# CONVAIR

## COMMERCIAL CHANGE PROPOSAL

SPEC NO.: ZD- 22-003

MODEL: 22-2 (Convair "880")

FIGURE 3.16-1

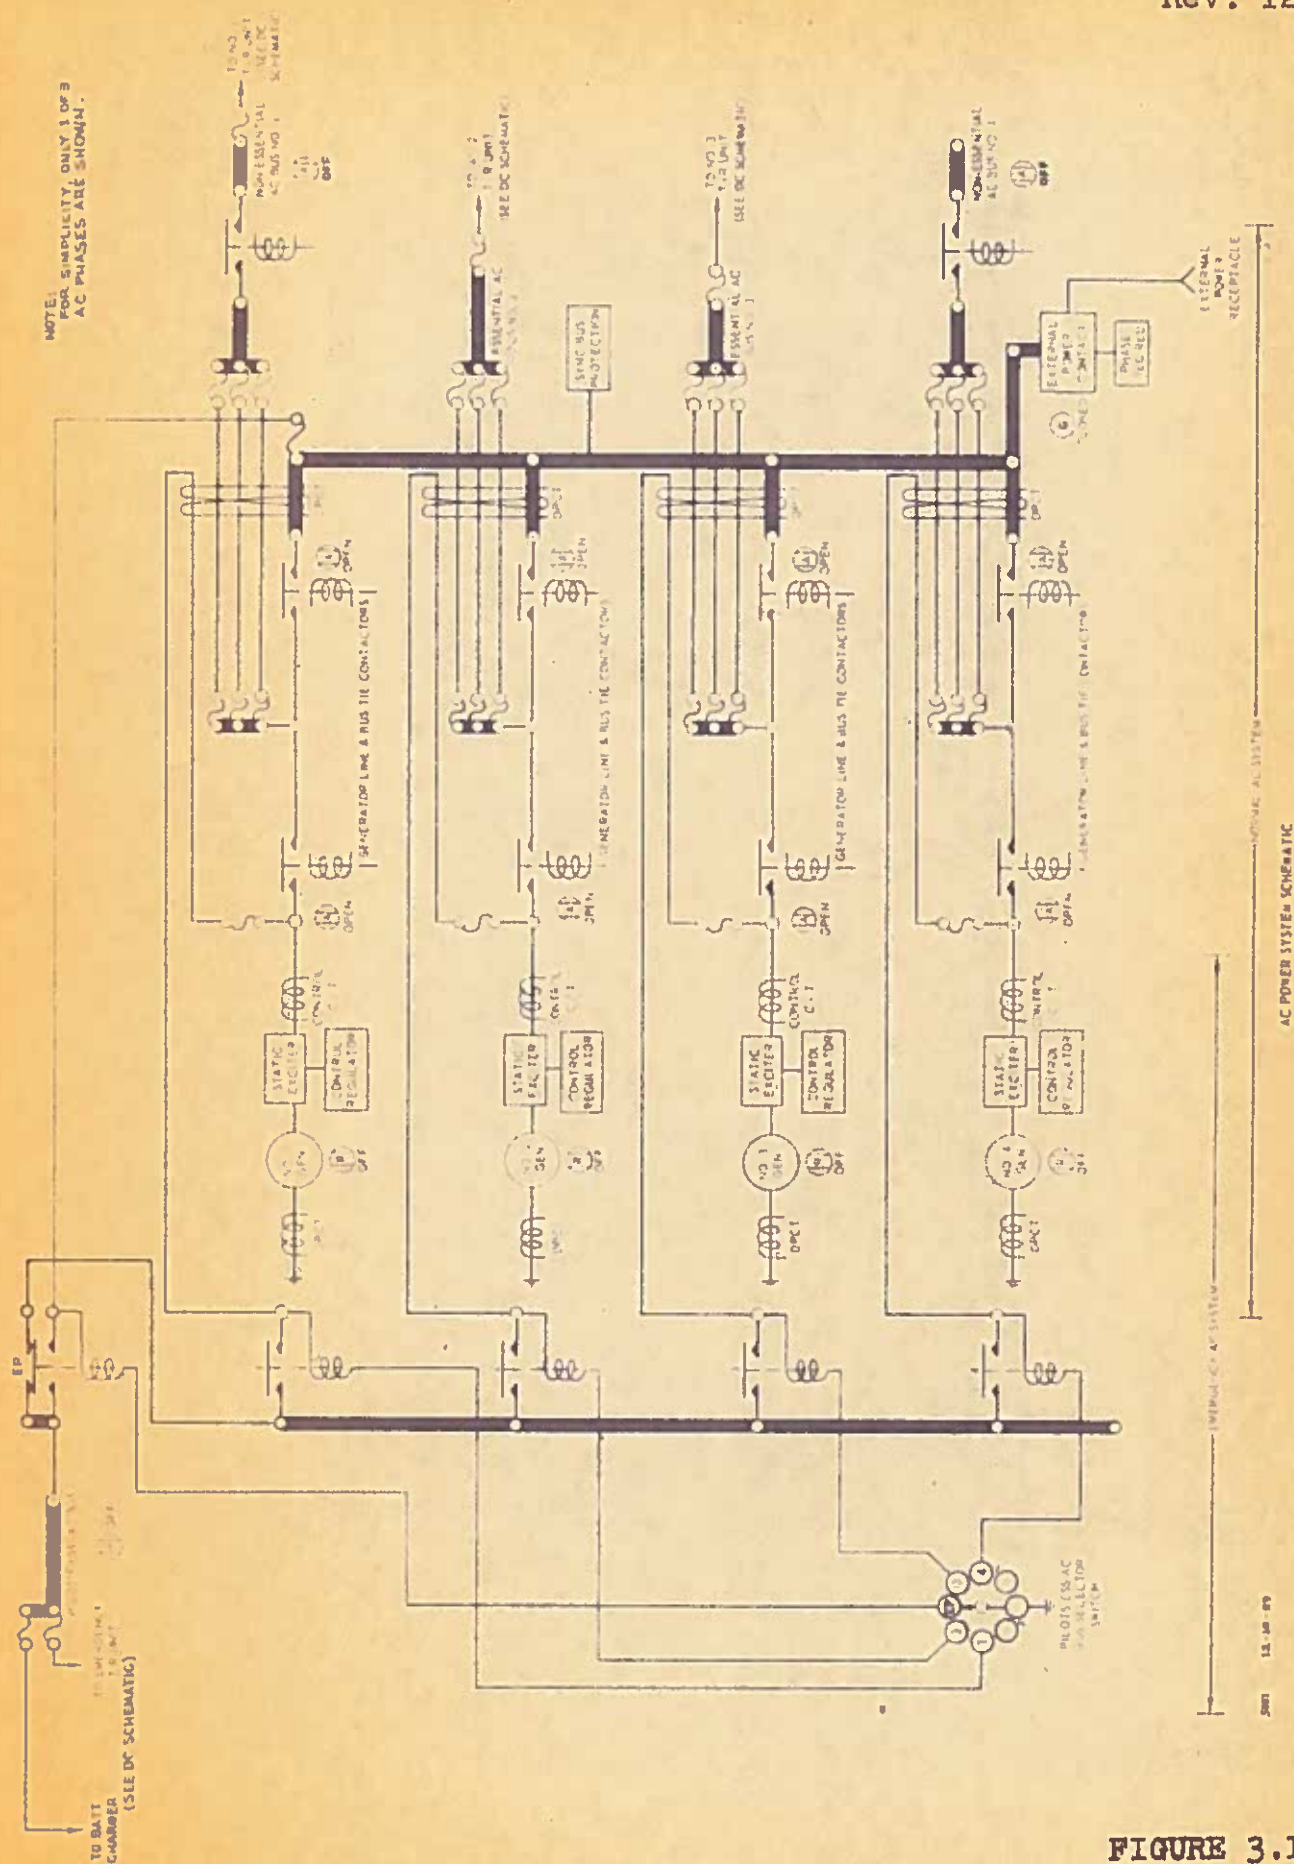
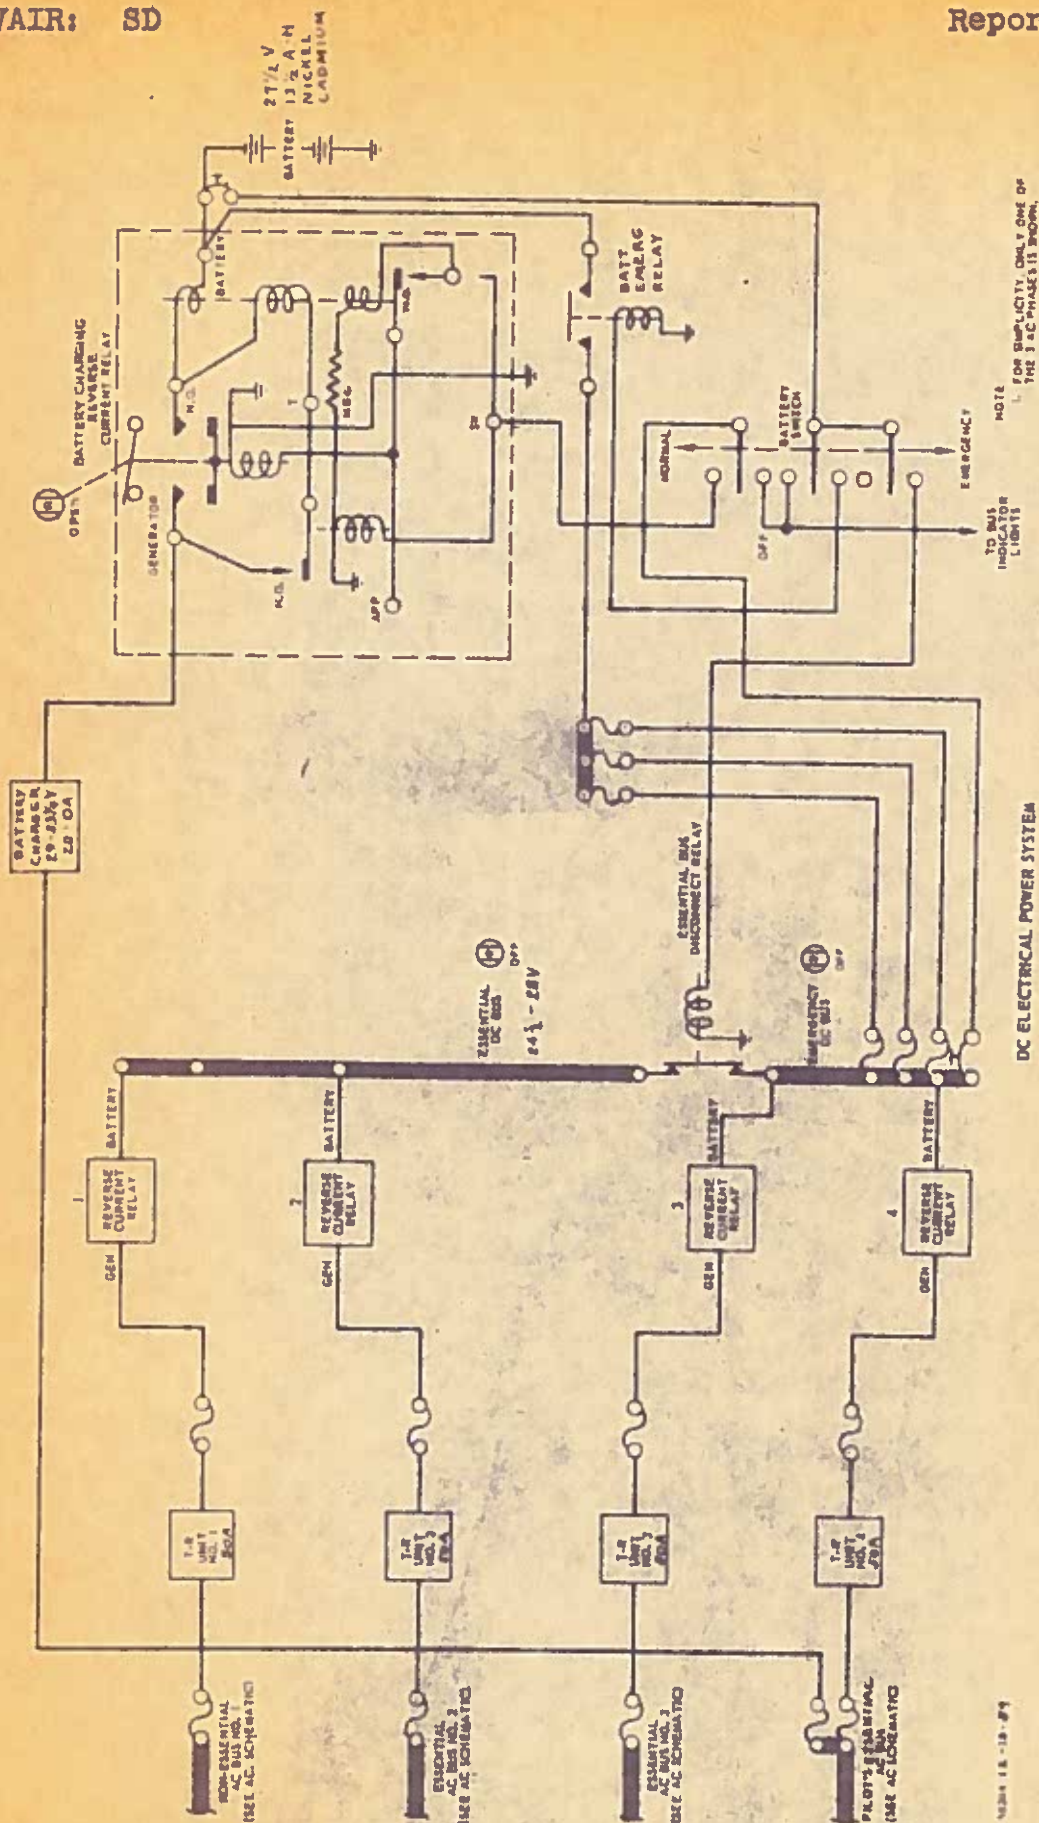
Reason for Change: To replace obsolescent and illegible illustrations.

One revised copy each of the above illustrations is attached hereto for Customer approval and subsequent incorporation into specification.

Figure 3.8-2

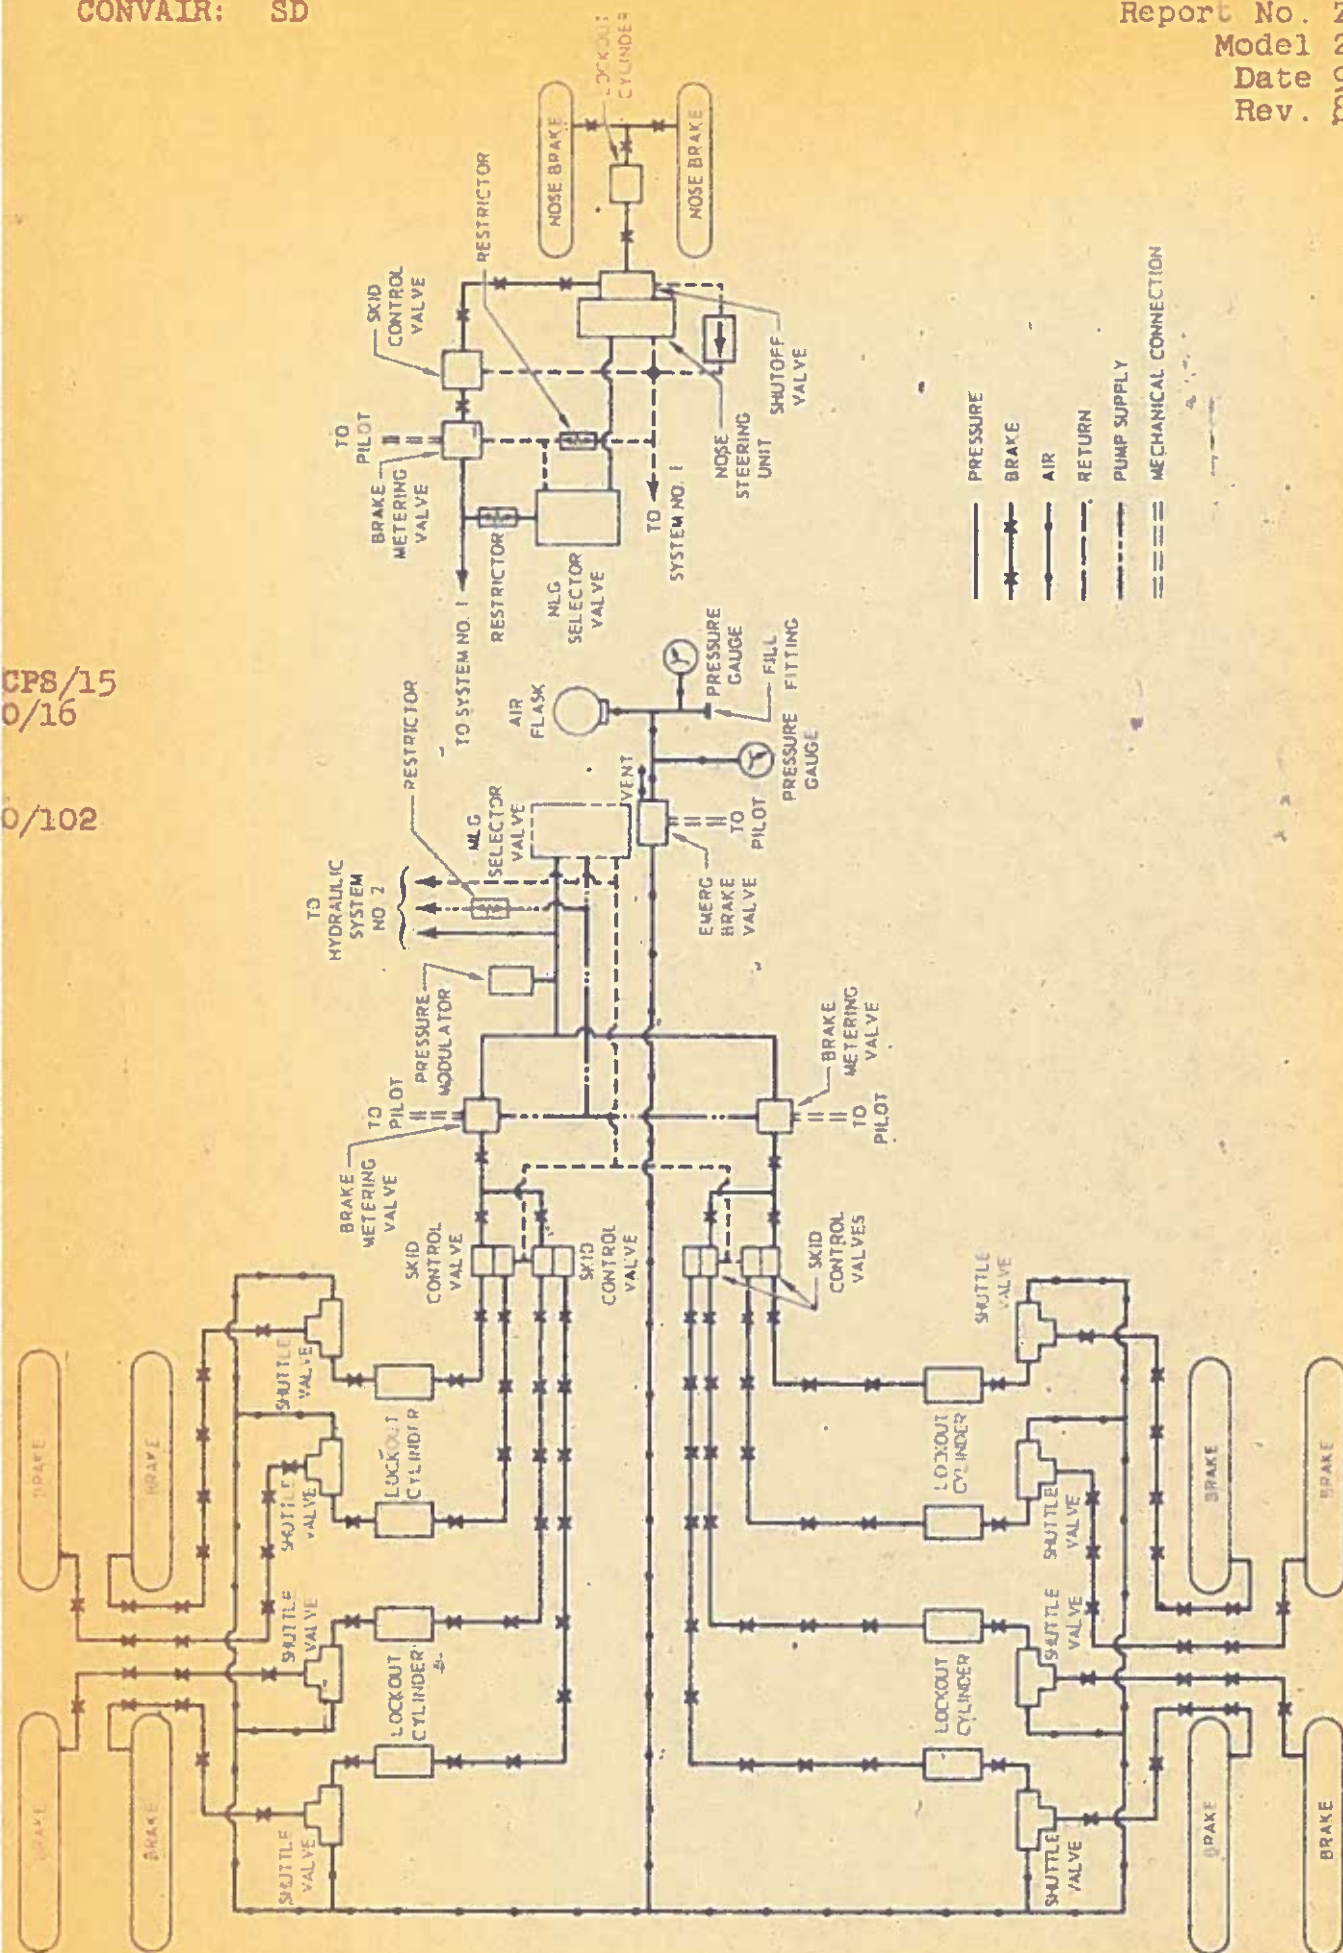
Replace above illustrations in specifications with Enclosures:  
(A), (B) and (C).

Enclosures: (A) One copy revised Page 38b - WHEEL BRAKE  
(B) One copy revised Page 38c - NOSE LANDING GEAR SYSTEM  
(C) One copy revised Page 64a - HYDRAULIC SYSTEM

Enclosure: (A) One copy Convair Sketch - AIR COND - TURBO COMPR. & RECIRC. FAN - MANUAL CONTROLS (For information only).

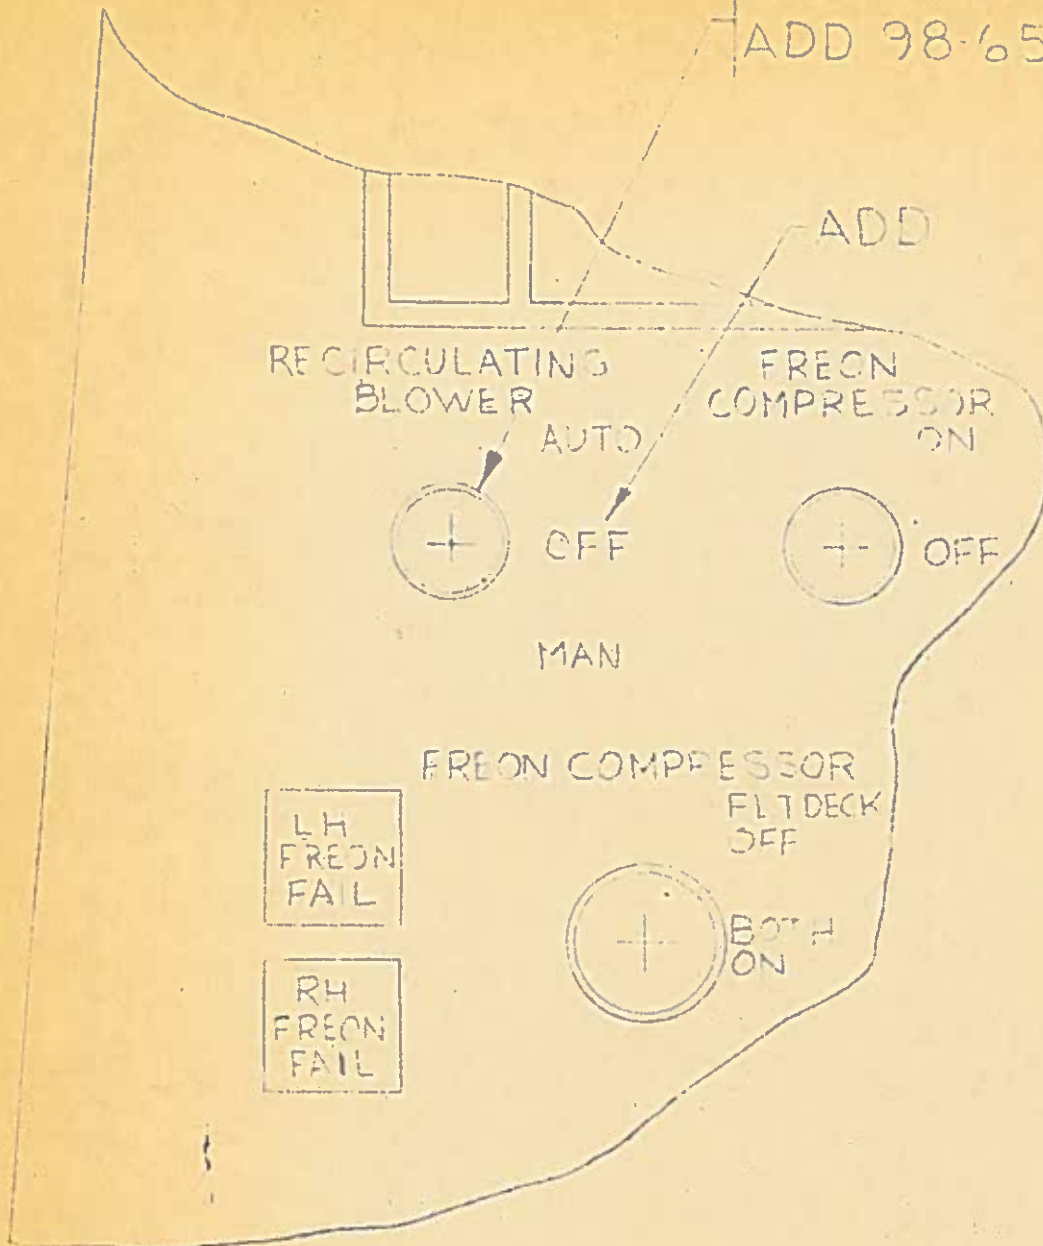
Page 122A, FIGURE 3.20-1 - AIR CONDITIONING PRESSURIZATION SYSTEM:

Above illustration will be revised to delete the fresh air check and control valves, items 10 and 35, in the ground air conditioning system.

Figure 3.14-6

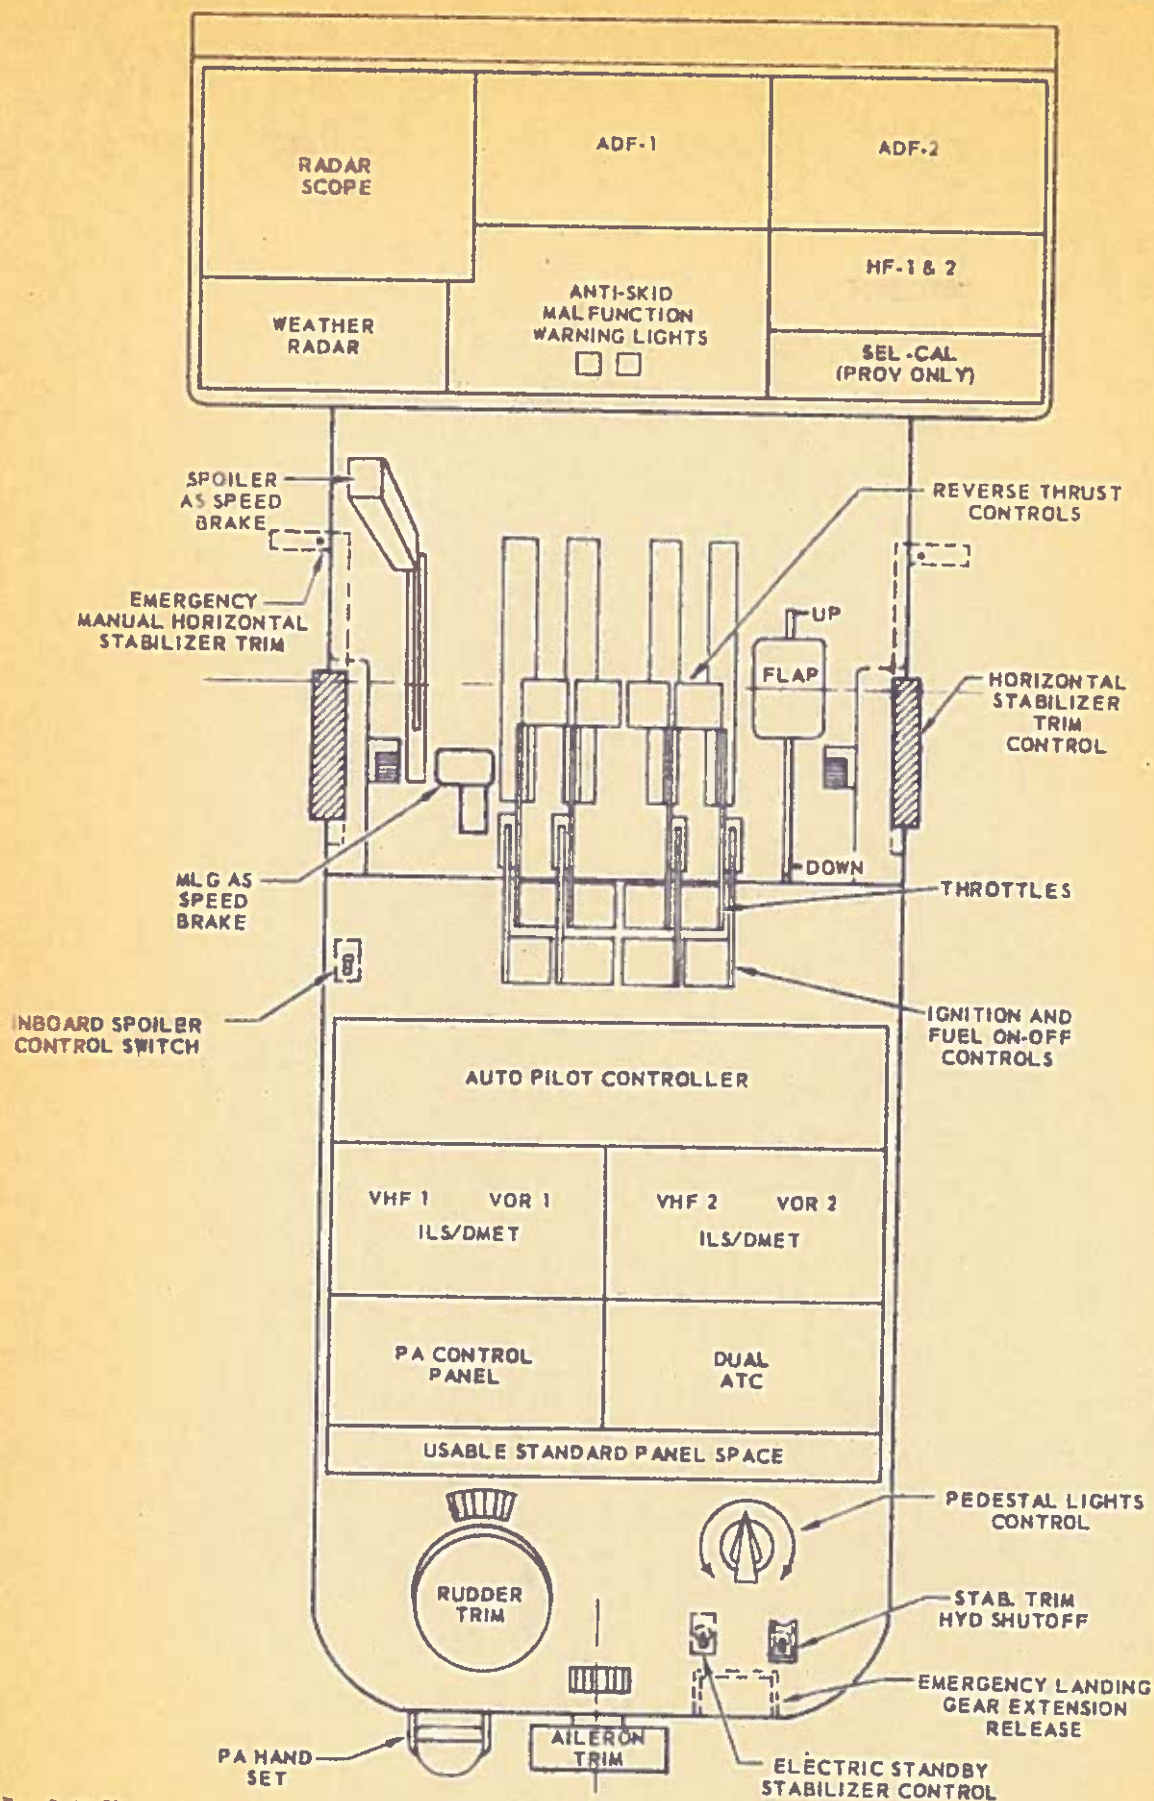
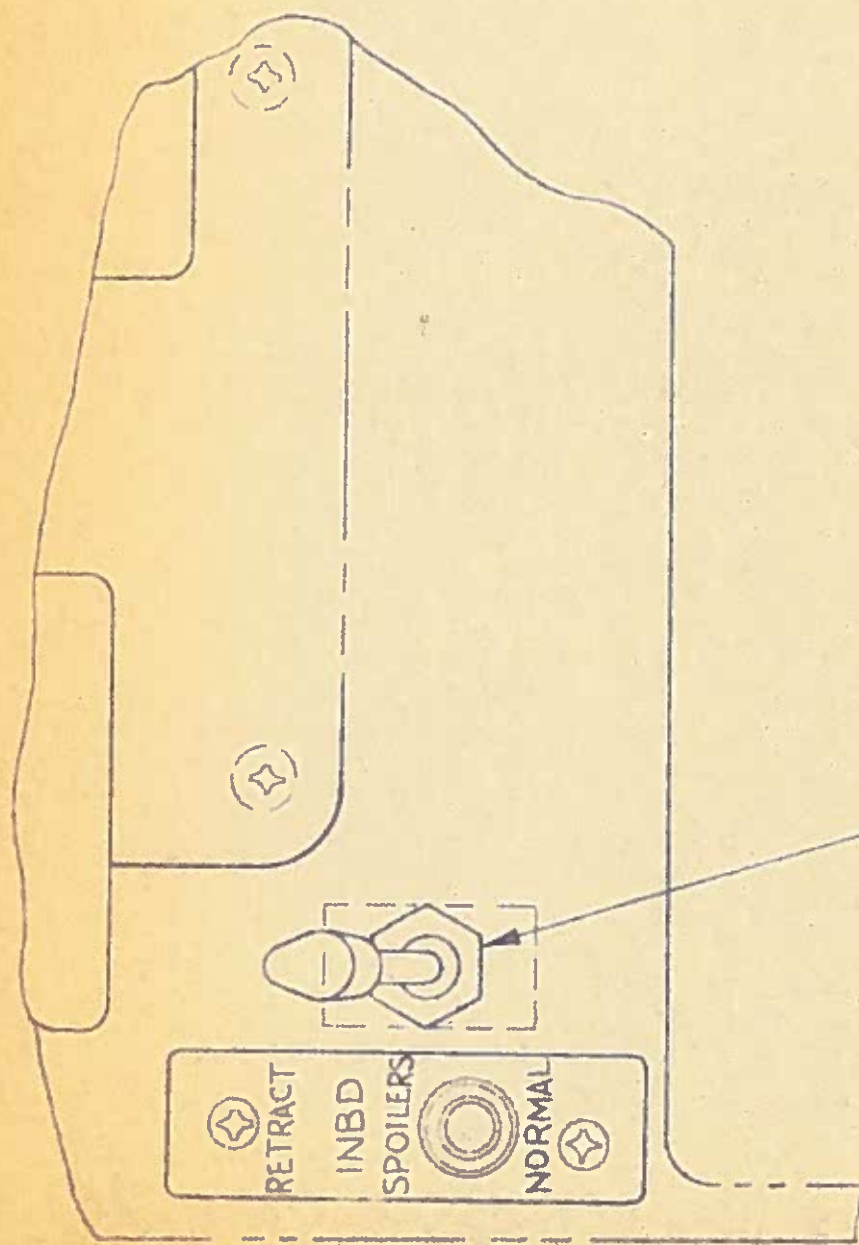
- Enclosures: (A) One copy of Figure 3.14-6, PILOT'S AND COPILOT'S  
PEDESTAL (Revised)
- (B) One copy of Convair Sketch showing labeling of Inboard  
Spoiler Switch (For information only.)
